STATE OF IDAHO  
OFFICE OF THE ATTORNEY GENERAL  
LAWRENCE G. WASDEN

Re: Alma Hubbard 27-76 & 27-11317

Hubbard POU

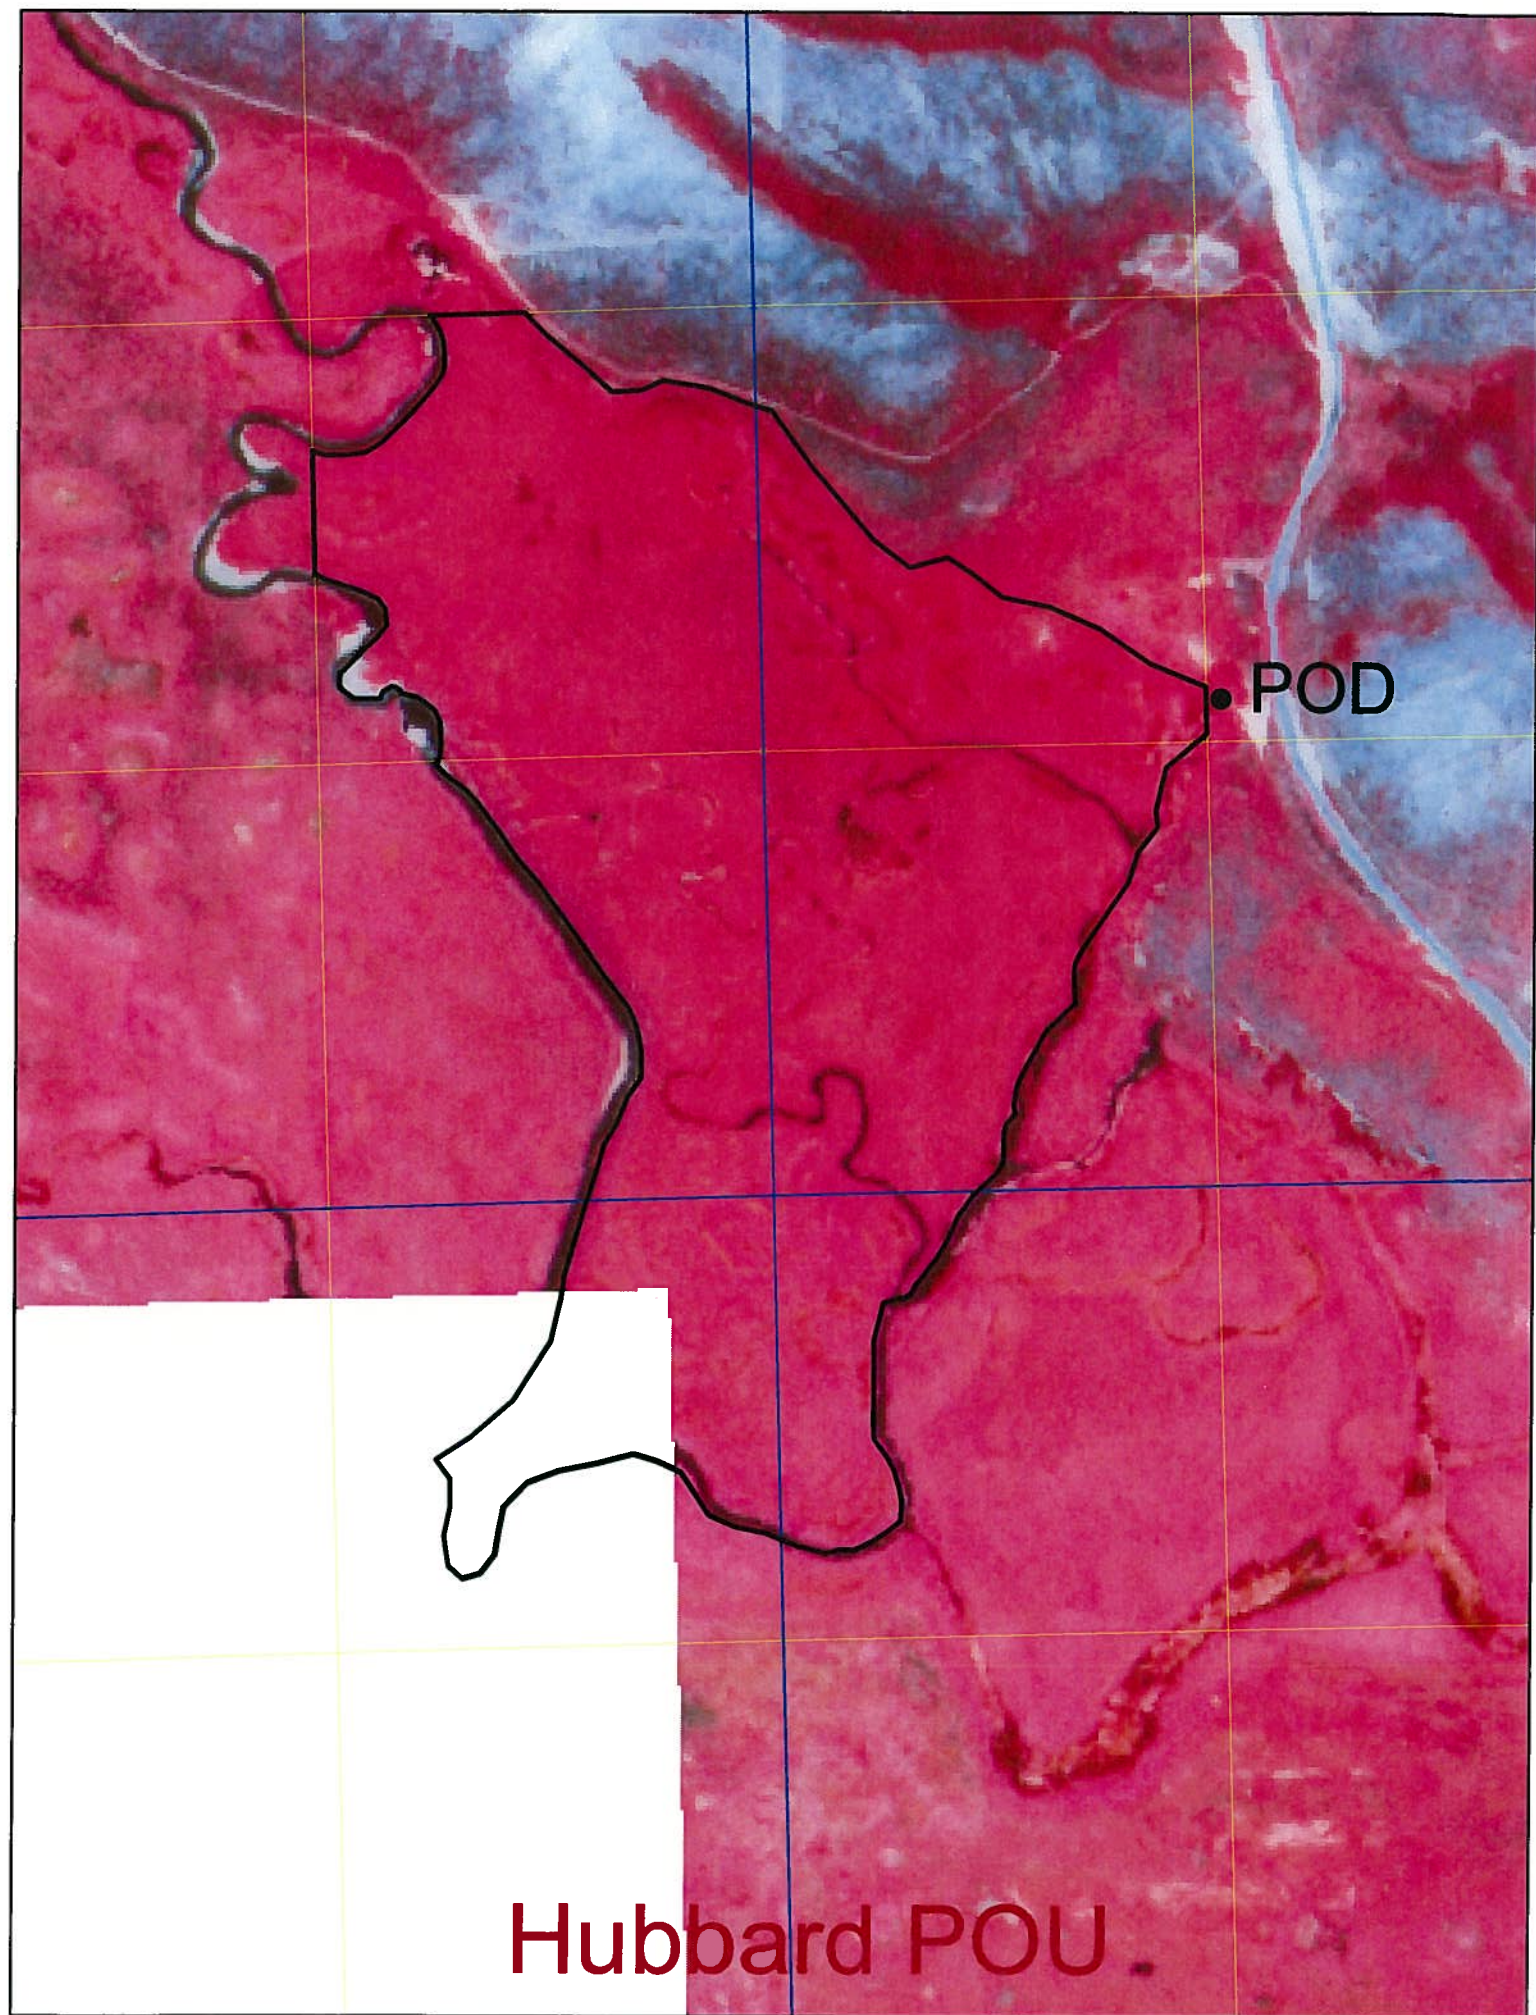
James has visited both the site of the POD as currently recommended for 27-11317 and the actual POD. The proper description of the POD location should be T05S R42E Sec 11 SWNESW, instead of T05S R42E Sec 11 SESWNW.

The POU description is also in error. James has walked the area and reviewed the POU on a topographic map. The land northeast of the ditch is higher in elevation and thus cannot receive benefits of any seepage from the ditch. Accordingly, the POU should be reduced to reflect the topography. Using the 1987 imagery, Michael calculated that the proper POU should be 117 acres. Attached for your reference is the proposed shape shown on 1987 imagery. Also attached is a topographic map showing the elevation lines for the proposed 117 acre shape and surrounding area. Because 27-76 and 27-11317 share the same irrigated POU, both would need to be revised to reflect the new acreage. The combined acre remark in the POU of both rights would need also to be revised to reflect the 117 acre POU. Additionally, the POU description for the stockwater purpose of use on 27-11317 should be the same as the irrigated place of use.

And finally, because of the revised acreage, the quantity needs to be correspondingly reduced. For 117 acres at the standard inch to an acre, the quantity

should be 2.34 cfs for irrigation on both rights. The quantity associated with the stockwater and domestic purposes of 27-11317 would remain unchanged.
